# Report from the 2<sup>nd</sup> meeting of CLIC ACE

> CTF3 Collaboration Board January 24<sup>th</sup>, 2008

Review and assess the R&D program for the RF structures towards demonstration of the full CLIC structures with nominal parameters by 2010 – both CAS and PETS

#### CLIC\_C versus CLIC\_G

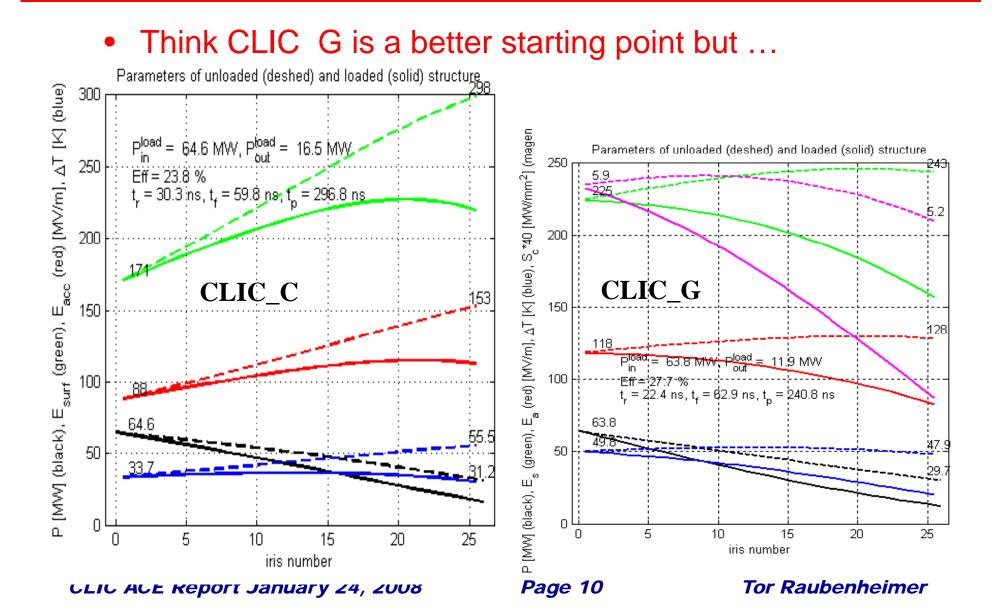
- Concern that small changes in optimization led to significant changes in structure design
  - Need to work backwards from 2010 date and determine date to finalize 'CLIC' structure design – is 2010 a 'hard' date?
  - Demonstration does not need to be 'final' structure but want to demonstrate near CLIC parameters (difference between 90 MV/m and 100 MV/m would not seem too important)
- Main goals:
  - Loaded gradient ~100 MV/m
  - HOM damping at required level
- Work on setting appropriate expectations
- Worry about optimization convergence
  - Large differences between CLIC\_C and CLIC\_G
  - Need to consider all LC systems
    - Particular concern about 6 bunch spacing for CLIC\_G
